GOVERNMENT OF MADRAS.

PUBLIC WORKS DEPARTMENT.

With reference to G.O., No. 5856 of the 23rd instant (Public Works Department No. 2619 W., dated 30th September 1891), I am desired to forward, for sanction and transfer to the Public Works Department for disposal, the accompanying plans and estimate, the latter, amounting to Rs. 7,920, for constructing an officers' messhouse with out-houses at Malapuram.

Note by the Chief Engineer, Public Works Department.

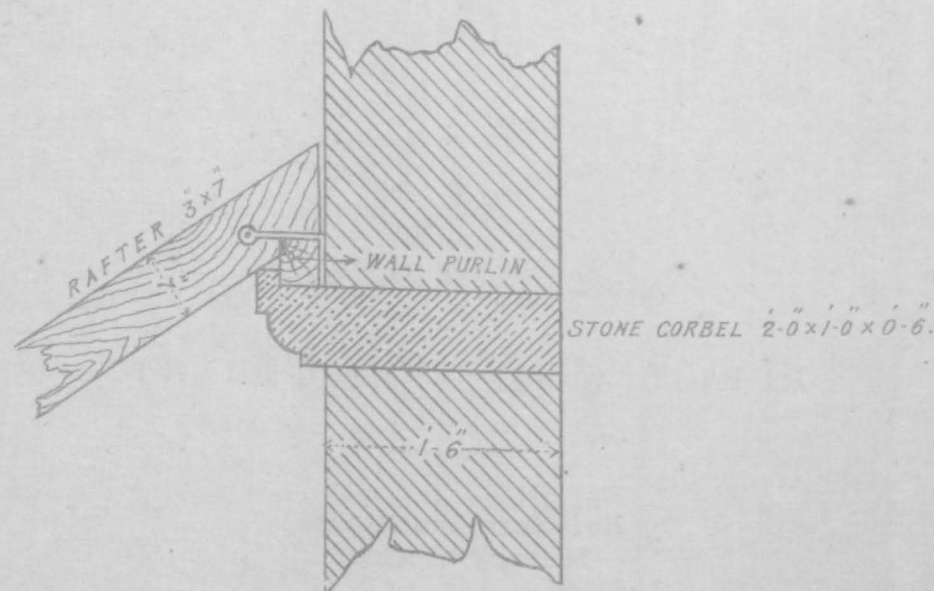
2. By the arrangement of supporting the roof on a single truss the end of the tie beam will come over the centre door. But by altering the position of the rear doors of the mess room so as to correspond with that of the end doors in the front wall and providing 2 trusses, 8 feet apart, of somewhat lighter scantlings, this will be avoided.

Tie beam	...	...	...	...	...	...	5½" × 4"
Principal rafters	...	...	...	...	...	...	4" × 4½"
Struts	...	...	...	...	...	...	4" × 3½"
Purlins	...	...	...	...	...	...	5" × 7"

3. The verandah rafters should be carried on wall plates supported by stone corbels 5 feet apart as per sketch.

2. The suggestions made by the Chief Engineer in his note above recorded should be carried out.

Note by the Chief Engineer
Public Works Department

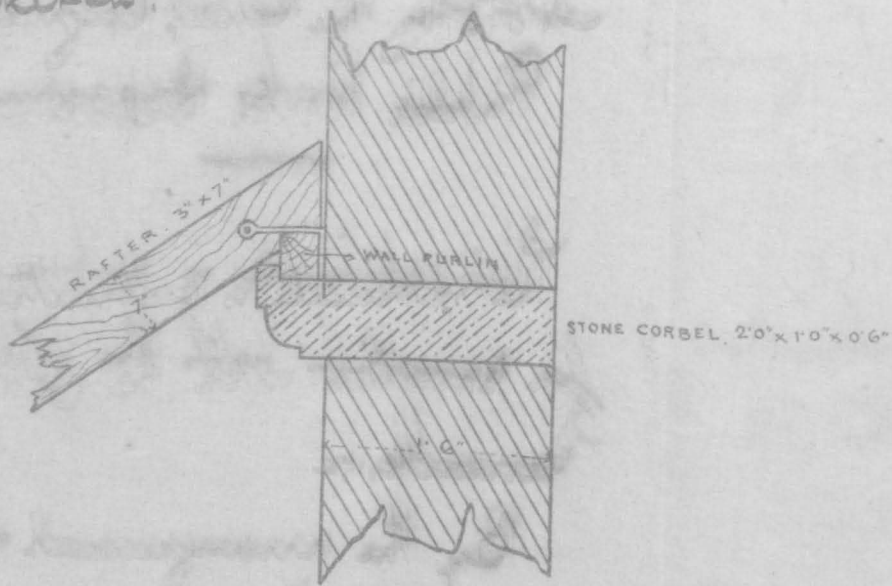
By the arrangement of
supporting the roof on a single
truss the end of the tie beam
will come over the centre door.
But by altering the position
of the rear doors of the mess
room so as to correspond
with that of the end doors
in the front wall and provide
ing 2 trusses, 8 feet apart
of somewhat lighter scant-
lings, this will be avoided.

The scantlings would be
Tie beam ——— 5½" x 4"
Principal rafters — 4" x 4½"
Sticks ——— 4" x 3½"
Purlins ——— 5" x 7"

The verandah rafters
should be carried on wall
plates supported by stone
columns

Corbels 5 feet apart, as per sketch.

Note by the Chief Engineer
Public Works Department

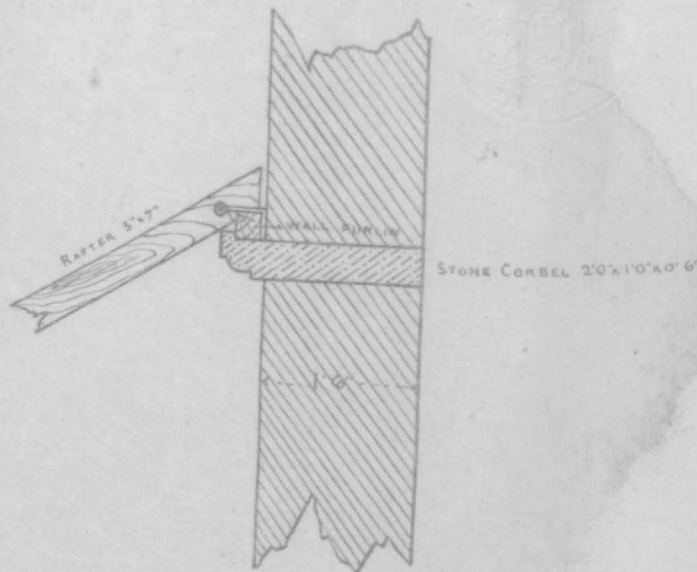
By the arrangement of
supporting the roof on a
single truss the end of the
tie beam will come over the
center door. But by alter-
ing ^{the} position of the rear door
of the mess room, ^{so as to correspond with} the end doors in the front
wall and providing 2 trusses
~~8 feet~~ 8 feet apart ~~with~~
of lighter scantlings, this
will be avoided.

Lie beam	5 1/2" x 4"
Principal rafters	4" x 4 1/2"
Stubs	4" x 3 1/4"
Purlins	5 1/2" x 6" 7"

The verandah rafters
should be carried on wall
plates supported by stone
Corbels

Corbels 5 feet apart, as per sketch.

This arrangement can be carried out for the same cost as that now proposed.

TECHNICAL NOTE.

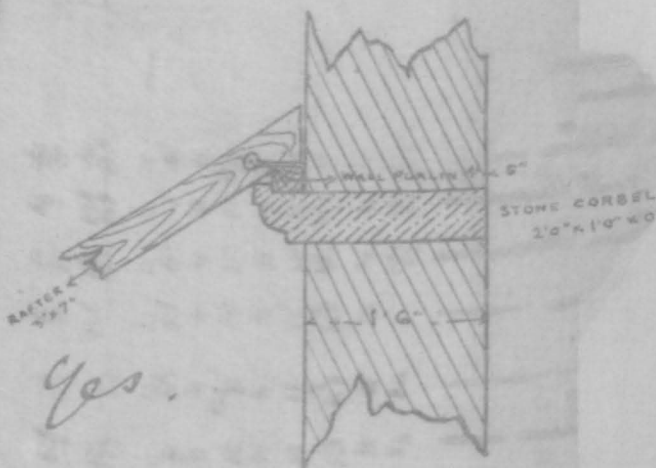
In the plan it is proposed
to support the roof of the new
room, which is 24 feet long by
one timber beam & 12 feet apart
with one end of the tie beam
resting just over the central
downway of the front verandah.
To avoid this, it may be
better to open 3 downways in
the rear wall similar to the
front face, and provide 2 light
wooden trusses 8 ft apart,
which will enable a partition
to be hung to the trusses & pulled
from the rear verandah also
more light & air will be admitted
in the new room.

Other roof timbers are correct
except the purlins which are
widened with a section of 6" x 8"
this section is considered heavy
it may be reduced to 4 1/2" x 6 1/2".
The number of wall plates have
been over estimated they are
now reduced from 6 to 3 the actual
quantity required.

The main rafters are let into
the main wall & nailed to wall
plates it would be a
better arrangement to support
the rafter with stone corbels placed
5 or 6 ft apart with purlins, as
per sketch.
